# Large Format Retail Zone Plan Change, Rolleston

## Integrated Transport Assessment

## Addendum in Response to RFI Queries

**Reference: PC240002 Private Plan Change Request to the Partially Operative Selwyn District Plan (V2) at 157 Levi Road, Rolleston**

**Figure 10-2: Indicative Vehicle Path from Southern Yard Access**

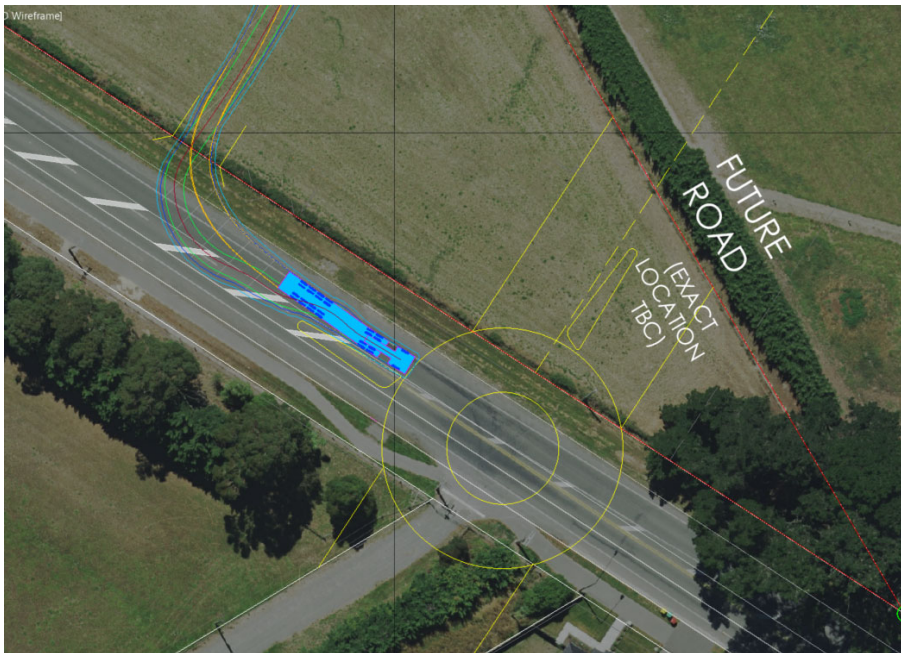
### **Question 3.4                      Access Safety**

*Section 10 shows that heavy vehicles are proposed to enter via the main site access on Lincoln Rolleston Road. Please comment on whether service vehicles sharing the same vehicle crossing and accessway in the site as the majority of customers will present any safety-related issues (noting that the Pak n Save consent only allowed for exit from this location, as noted on page 15).*

Expected design changes are addressed at Section 10 of the ITA noting a localised modification to access is expected to be required to ensure heavy vehicles can enter without being in conflict with the opposing exit lanes.
